ADDENDUM NO. 1  
TO  
CITY OF AUBURN, MAINE  
2021 RECONSTRUCTION PROJECT  
April 23, 2021

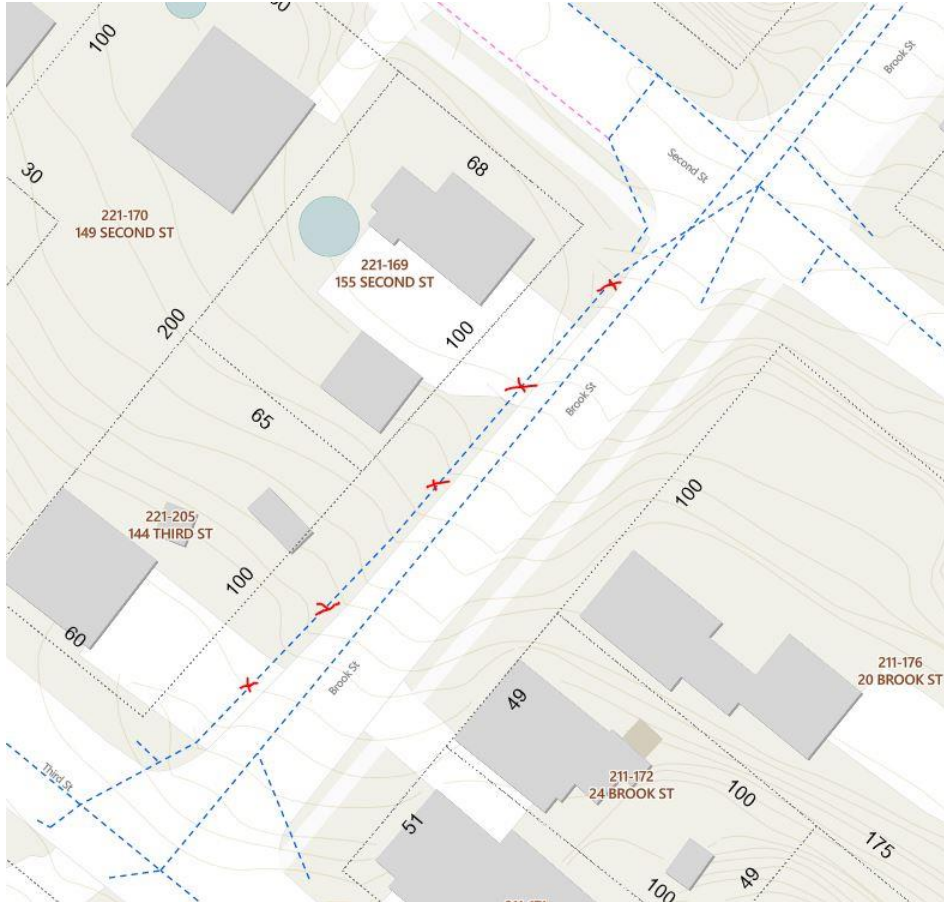
Question: Is there an existing storm drain on the right side of Brook Street that the new one is being proposed as seen in your GIS system?

Answer: There is an existing storm drain in that location, however the proposed pipe may require a different elevation and also does not necessarily follow the same trench. The length is included in the pipe removal bid quantity. See below for GIS mapping for reference.

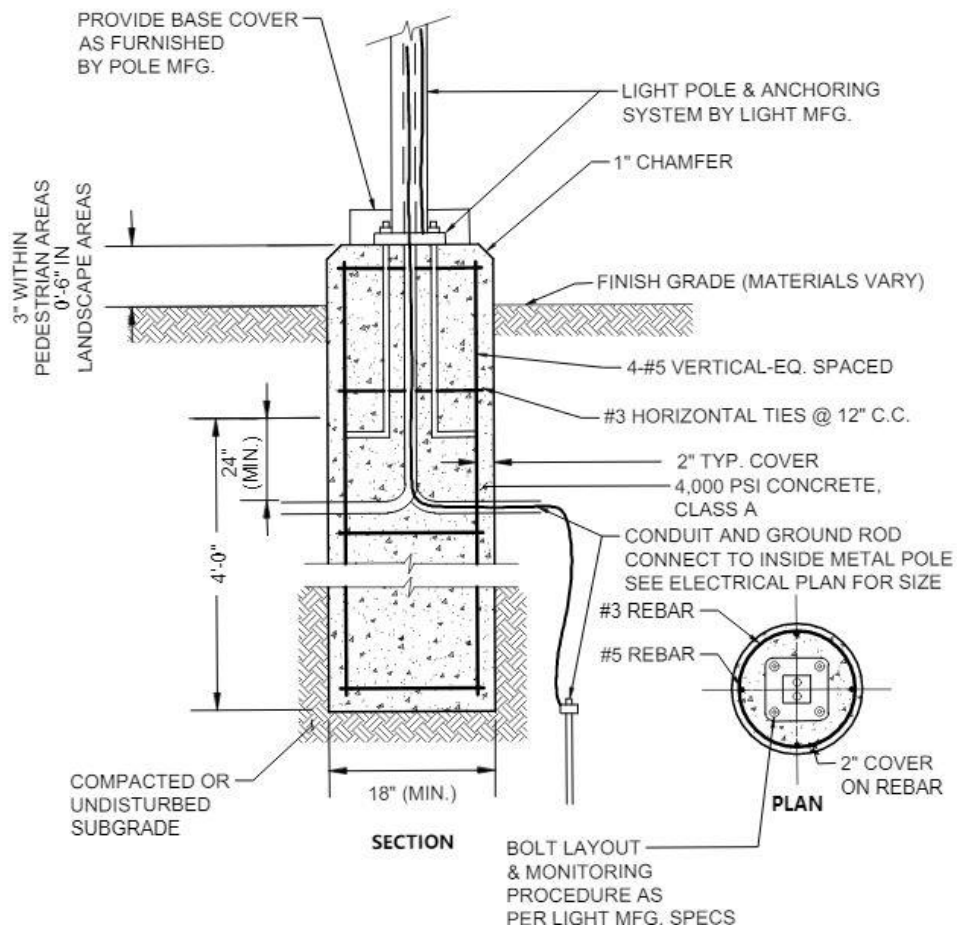
Question: Are there any specifications outlining the parameters for precasting these bases? Is there any information on the dimensions of the foundation bases for the lighting standards?

Answer: The current lighting layout is conceptual and a final plan will be agreed upon by the Contractor and City Electrician. Conduit quantities will be based on that final lighting layout. The template and anchor bolts will be specified in with the lighting standards. Below is a typical detail for the base dimensions and reinforcement, however ground rod is not required.
